18C Operator Interface Equipment Characterization

The information in this appendix of the reference ABWR DCD, including all subsections and figures, is incorporated by reference with the following departure and a supplement.

STD DEP T1 3.4-1

Figure 18C-8 Overall Configuration of Operator Interface System

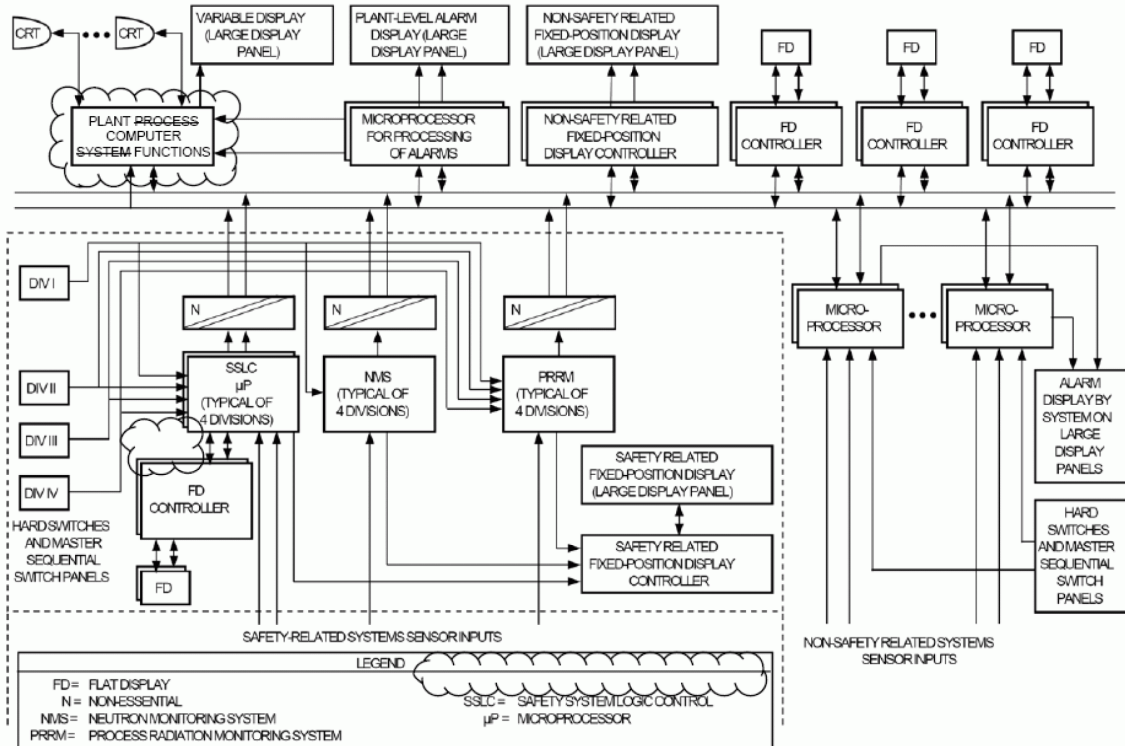
A characterization of the plant instrumentation and control systems architecture which supports the control room operator interface is illustrated in Figure 18C-8. As shown in Figure 18C-8, display and control capability for both safety-related and non-safety related systems are driven by microprocessors which are independent of the redundant plant process computer functions. This assures the ability to safely shut down the plant in the unlikely event of computer failure. In the case of the safety-related systems, the microprocessors are divisionally dedicated and are each electrically isolated from the rest of the system.

The instrumentation and control systems architecture is not identical to the conceptual design described in Appendix 18C. The changes in the next paragraph reflect the architecture and configuration.

~~The plant-wide, fiber-optic Essential Multiplexing System (EMUX) provides the communications network for the system. This multiplexing system is actually a series of data acquisition and control networks, separate networks being provided for safety related and non-safety related plant systems. The data communication function includes both safety-related and non-safety related communication performed by separate networks as described in Section 7.9S.~~
